ADDENDUM No. 3

ITB #: 2018-19-3210-00-009

RE: ITB – NW 97TH AVE FROM NW 154TH ST TO NW 162ND ST – PHASE 1 –

ROADWAY AND DRAINAGE IMPROVEMENTS

PARTIAL ELECTRICAL SITE PLAN FROM STA. 117+75 TO STA. 124+00

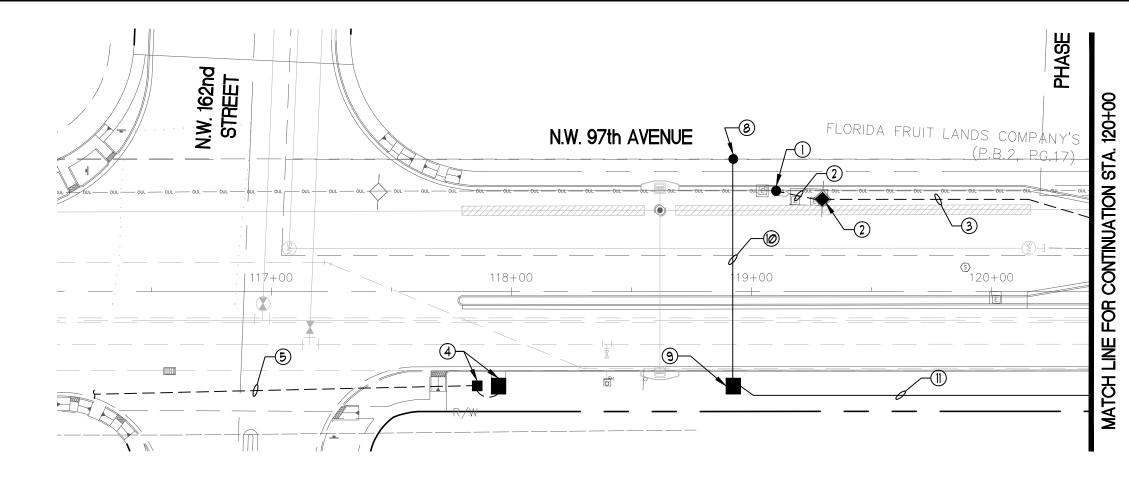
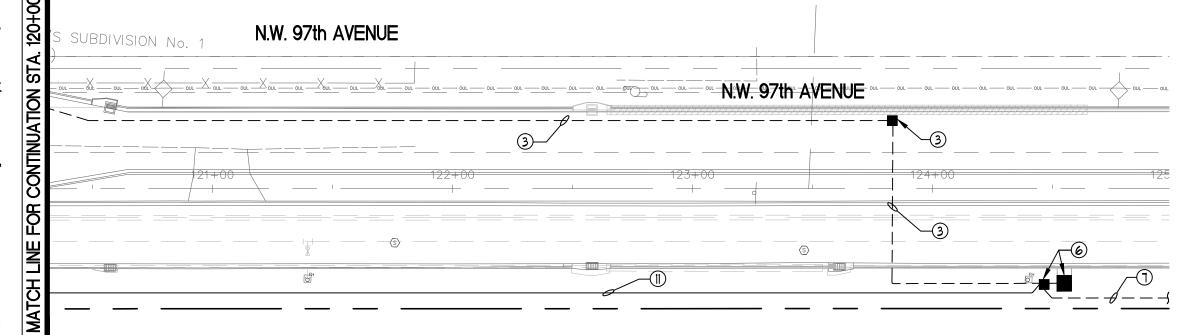
ATI Question No. 3: Bid Form has an item for "Service Pole Relocation (1 EA). Where in the plans can we find it?

City's response: See attachment 4 – Electrical Plans
